Access Report

LaHC Seniors Housing Development 36-38 Birdwood Avenue PAGEWOOD NSW

For: CKDS Architecture Ref: LP_21452

Documentation for the LaHC Pagewood development located at 36-38 Birdwood Avenue Pagewood has been reviewed against current and applicable accessibility legislation.

Figure 2 | Location of the Site

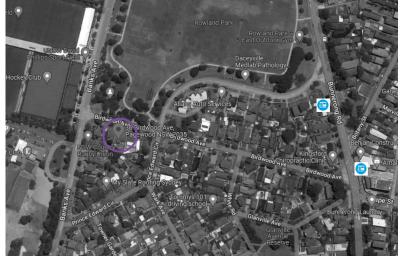
The site lies within 450m of bus stops along Bunerong Road. While this exceeds the allowable travel distance specified by the SEPP, we note that a formed and level footpath infrastructure is an

existing condition. The additional 50m is not seen to adversely affect access to the bus stops for residents of the development.

The bus stops are identified as following and noted as accessible bus stops on the Transport for NSW website.

- Bunerong Rd at Prince Edward Cir Stop ID: 203520
 450m from the development site
- Bunnerong Rd opp Birdwood Ave
 Stop ID: 203225
 410m from the development site
